Euchanhead Renewable Energy Development

Additional Environmental Information
Non-Technical Summary

Eucharhead Renewable Energy Development AEI

Non Technical Summary Site Layout

Eucharhead Renewable Energy Development AEI		Drg No	428.013391.00001.0005.0	
Non Technical Summary Site Layout		Rev	A	Datum: OSGB36
		Date	11/04/25	Projection: OSNG
		AEI Figure	2

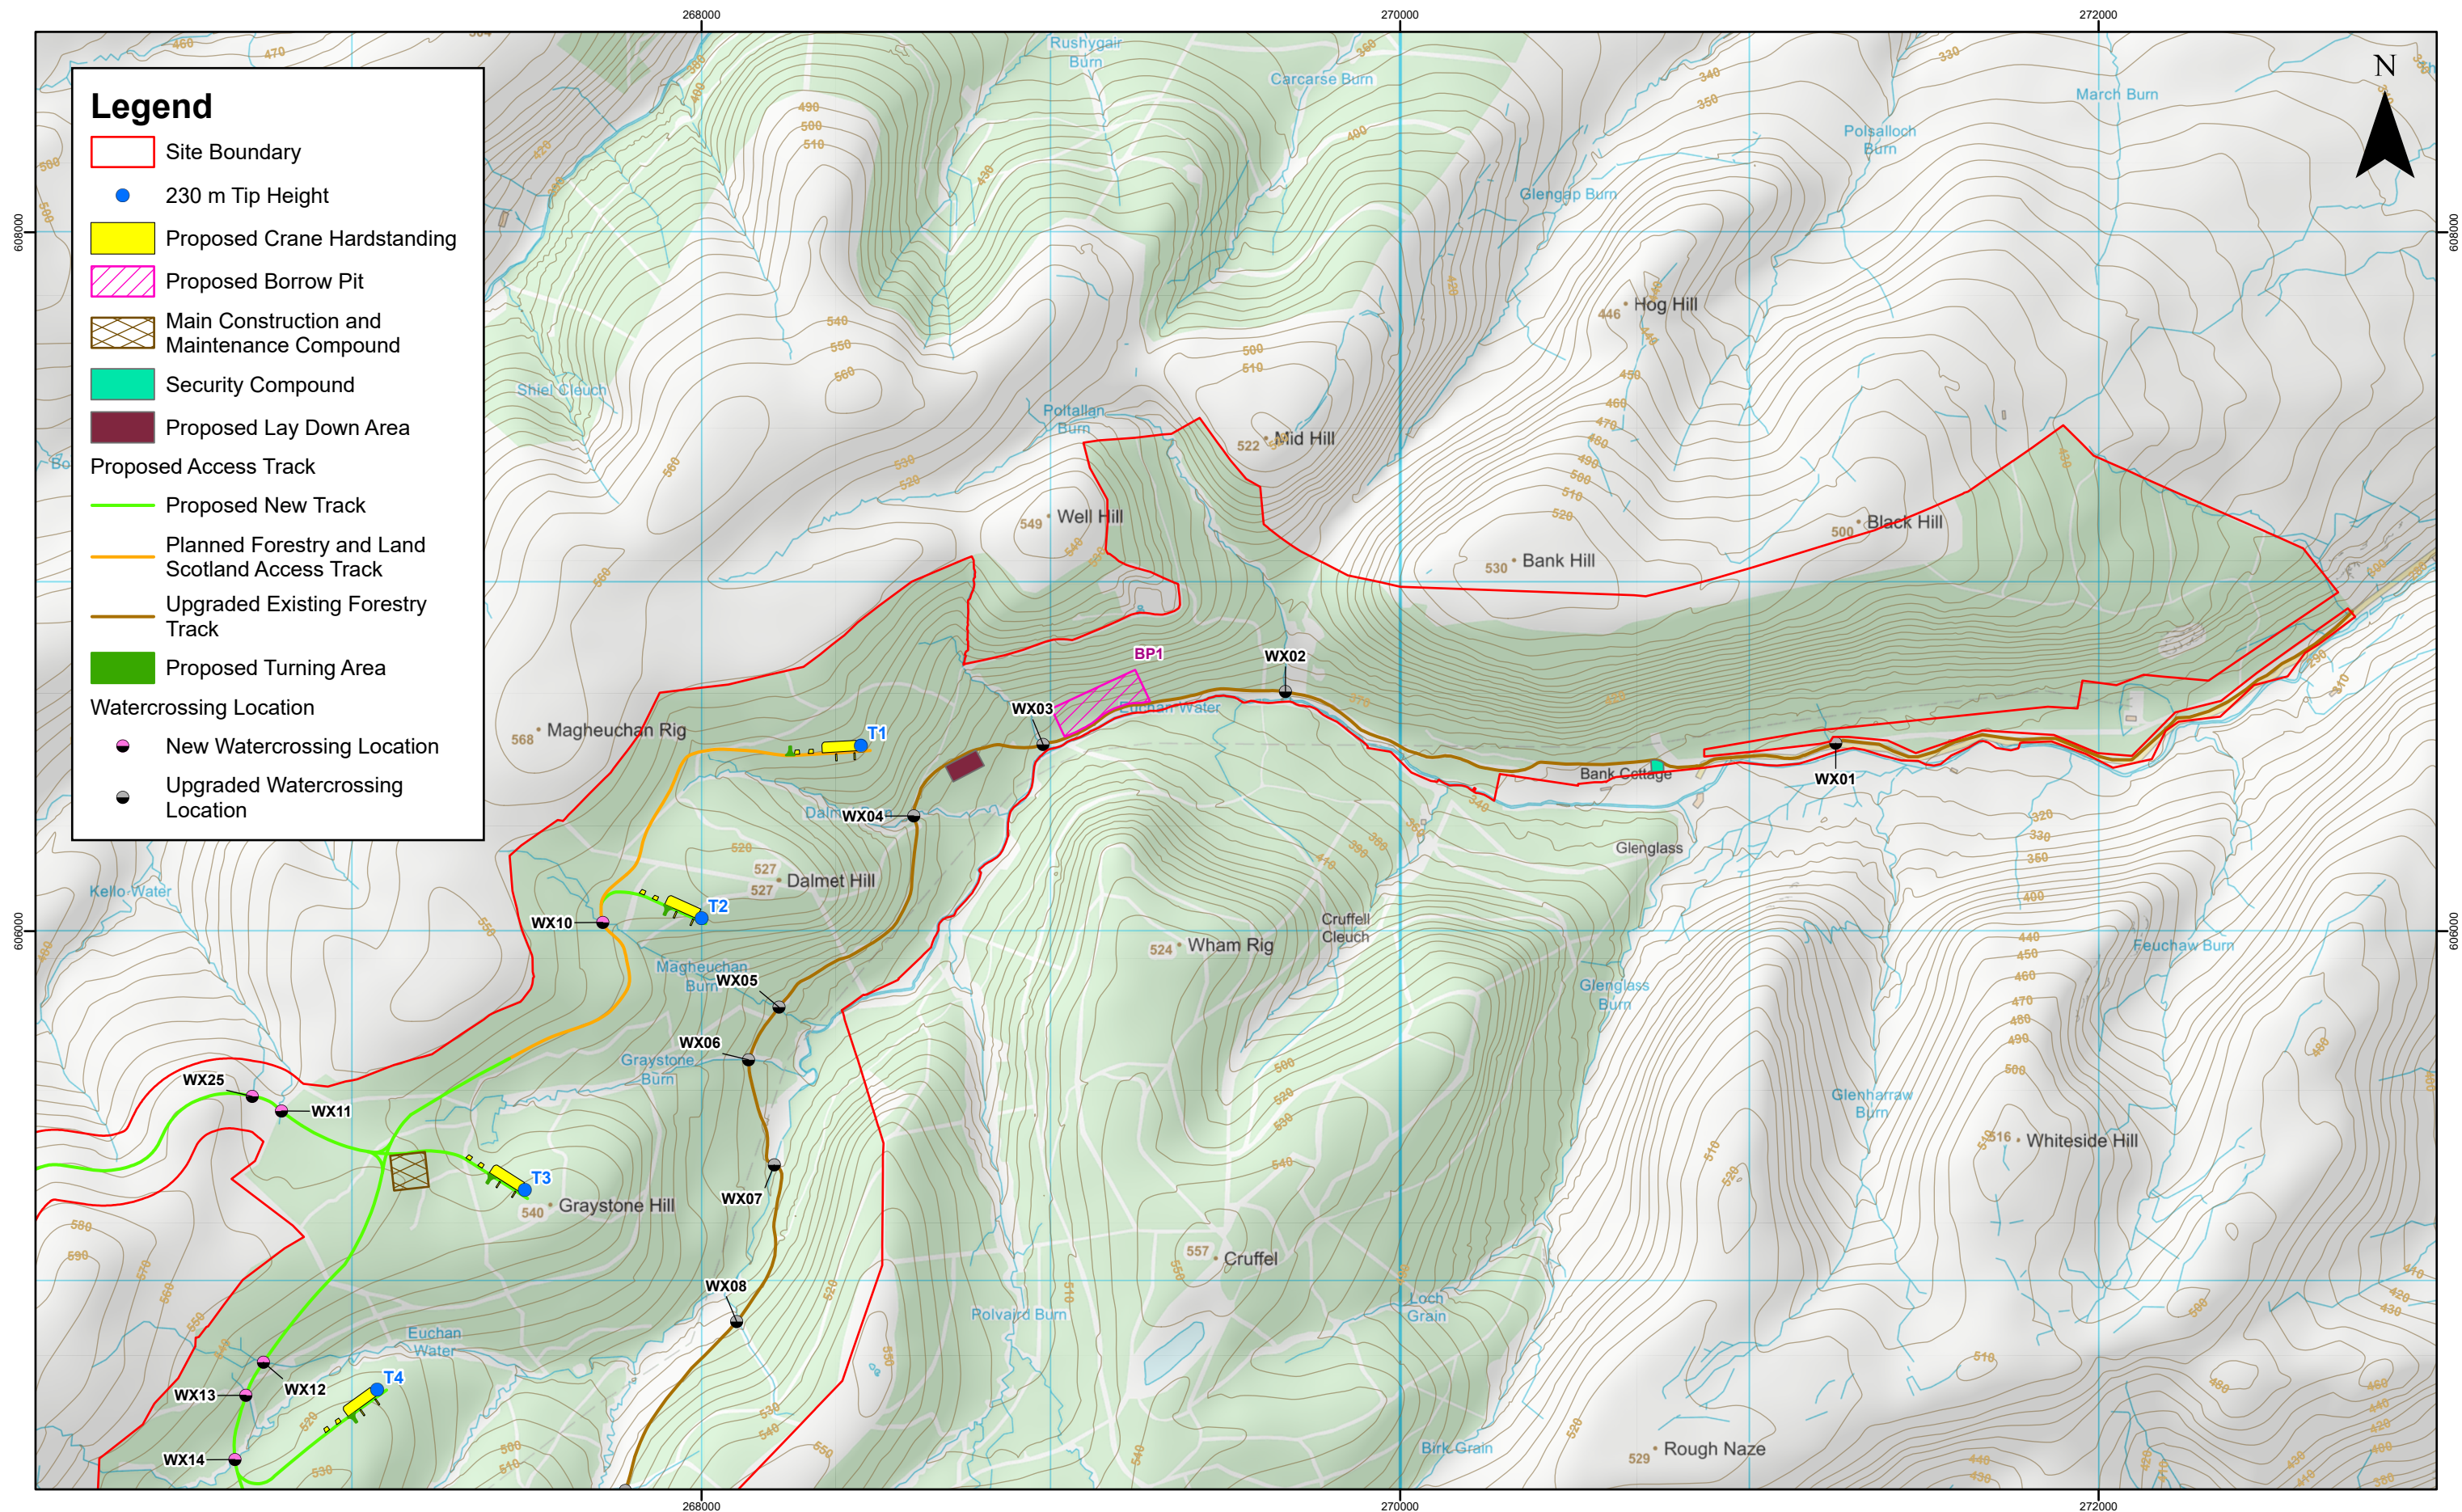
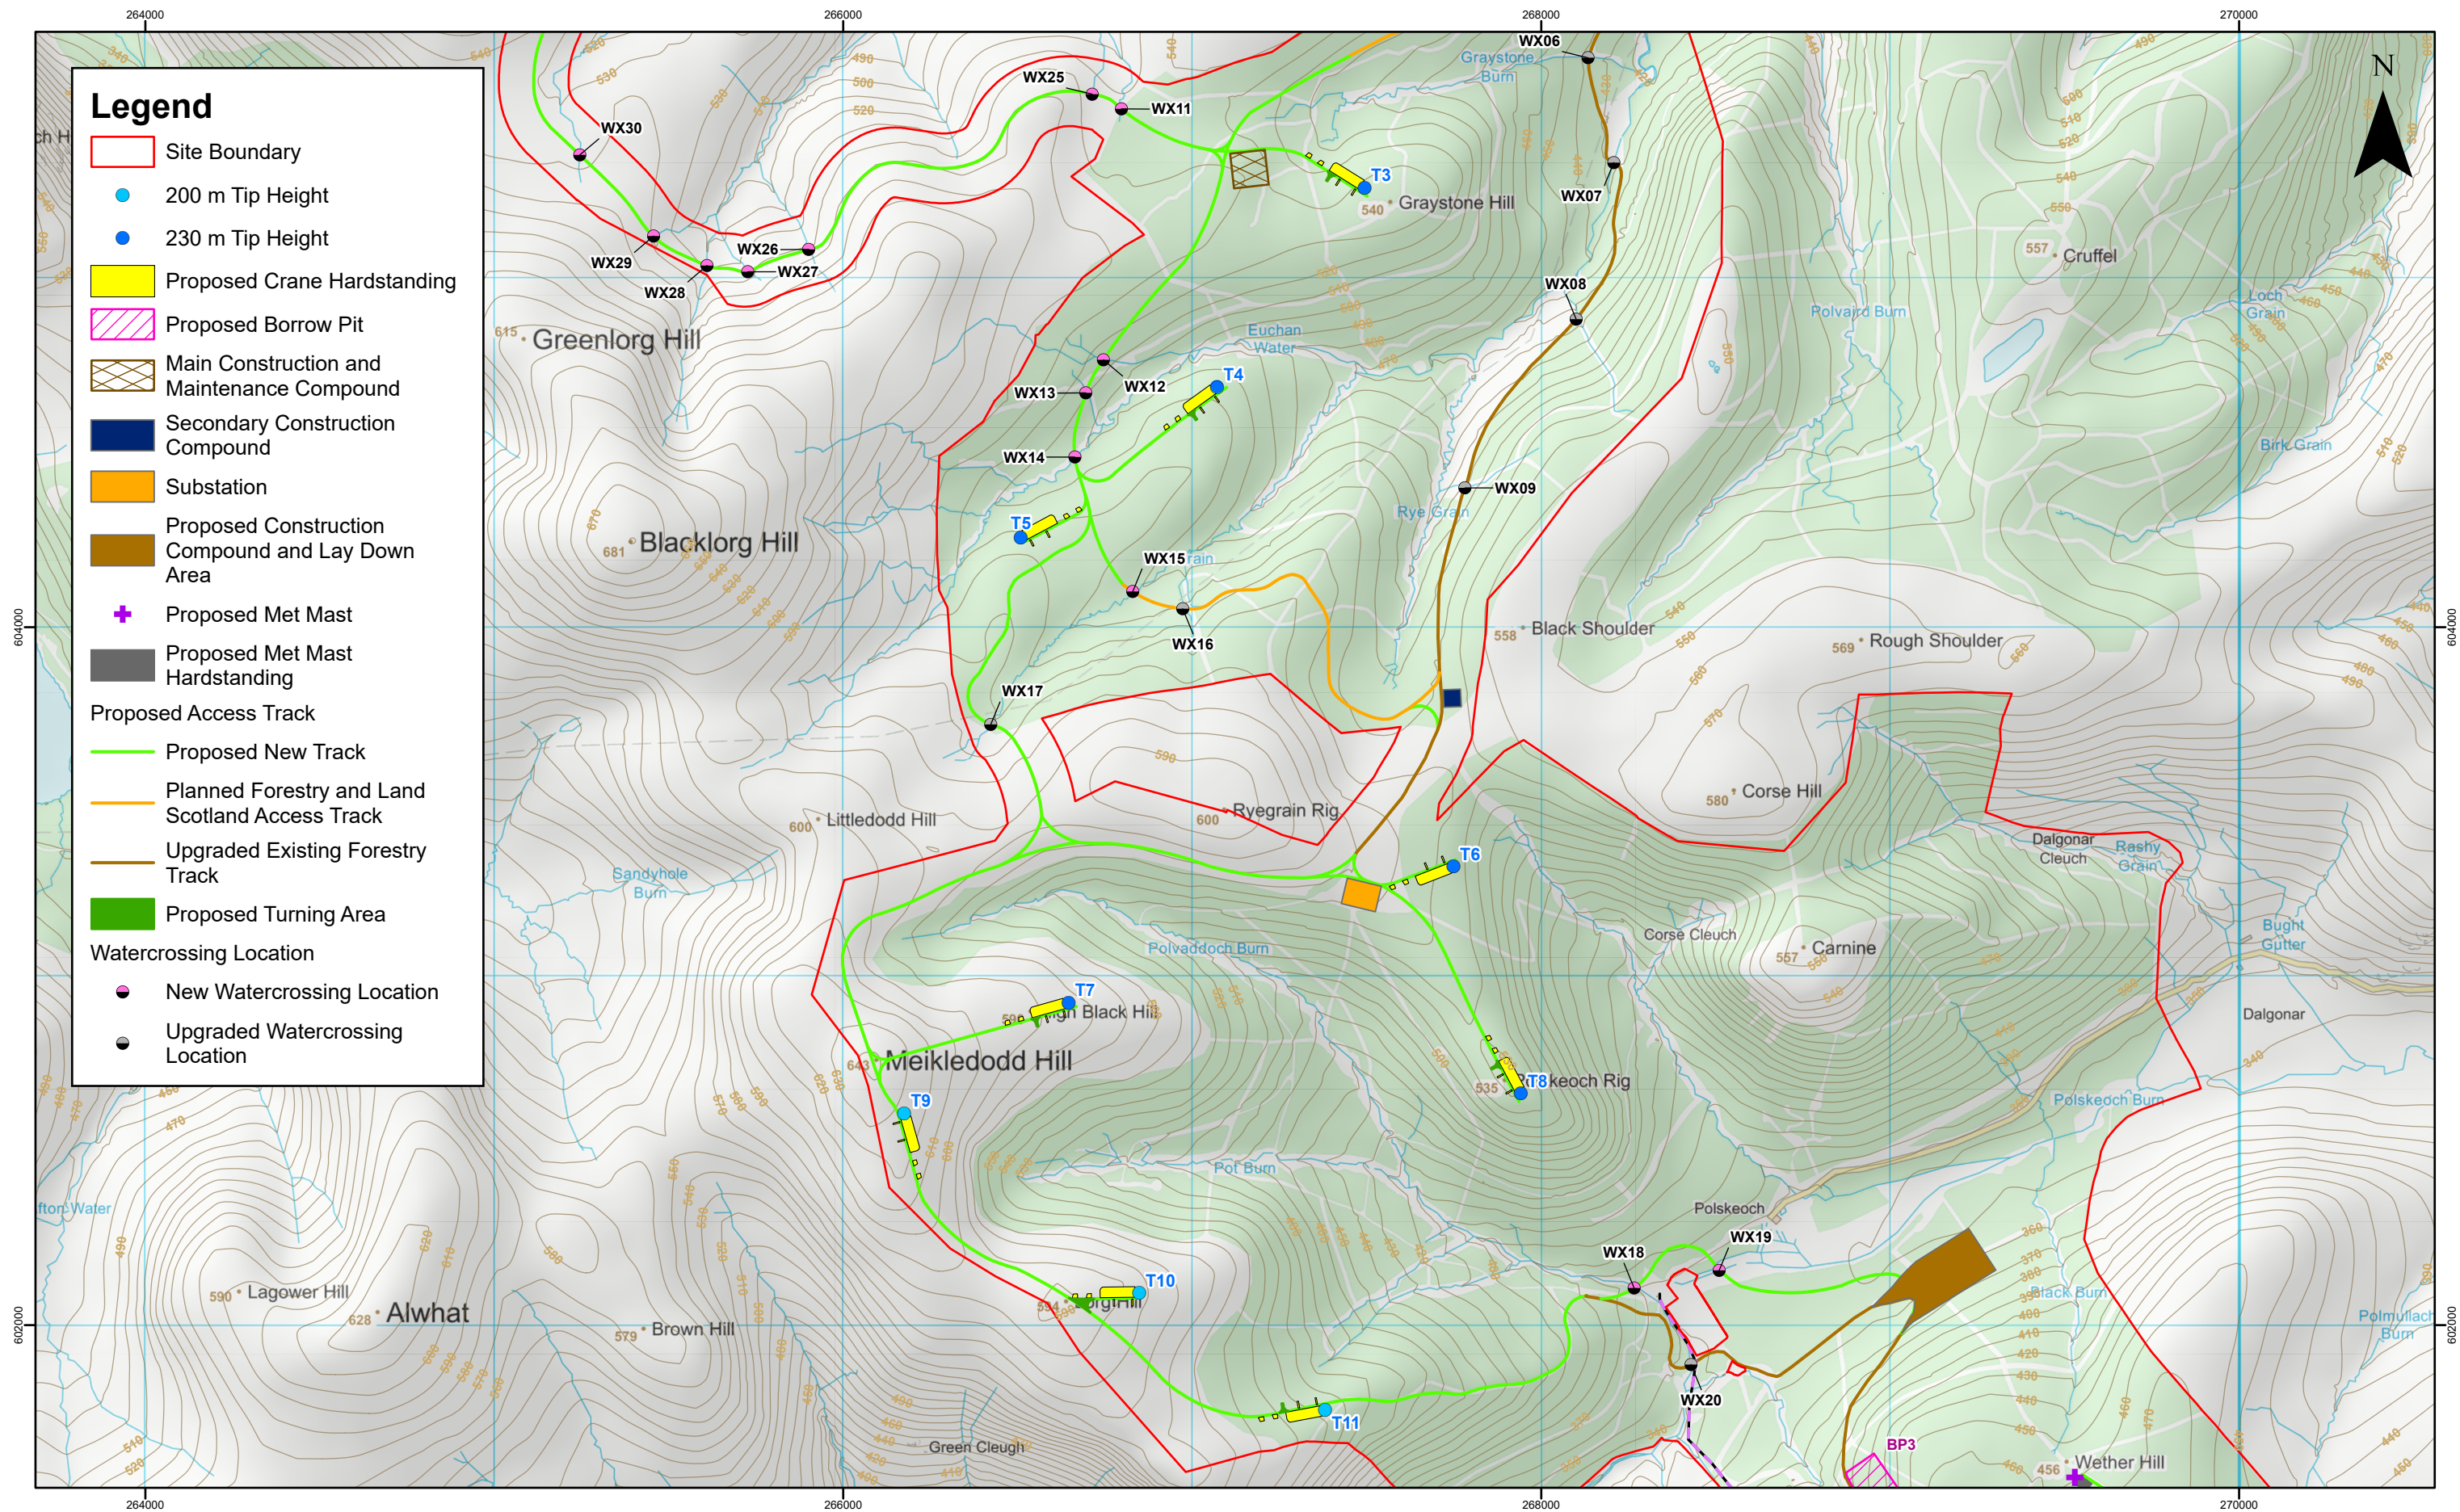
The DGC landscape architect, in a consultation response dated 29 March 2023, highlighted that several turbines—specifically Turbines No.9, No.10, No.11, No.19, No.20, and No.21—were consistently problematic in terms of their visual impact. These turbines were considered to detract from the fit of the scheme within the surrounding landscape and in relation to other established wind farm developments.

In response to consultation feedback, particularly from DGC, the design of the proposed Development was refined to reduce its landscape and visual impact and improve integration with the surrounding landscape. The design amendments focus on the removal or height reduction of the specific wind turbines highlighted as a concern by DGC. **Table 3:1** below details the amendments made to the Site Layout.

Site Infrastructure	Summary of Changes from EIA Report to AEI
Turbine No.20 (and crane pad)	Removed entirely.
Turbine No.21 (and crane pad)	Removed entirely.
Turbine No.9	Blade tip height reduced from 230m to 200m.
Turbine No.10	Blade tip height reduced from 230m to 200m.
Turbine No.11	Blade tip height reduced from 230m to 200m.
Turbine No.18	Blade tip height reduced from 230m to 200m.
Turbine No.19	Blade tip height reduced from 230m to 200m.
Access Track to Turbine No.20	Approx. 1,130.72 metres of proposed access track removed.
Access Track to Turbine No.21	Approx. 1,231.85 metres of proposed access track removed.

These design amendments are reflected in the updated NTS Site Layout Figure – AEI Figure 2.
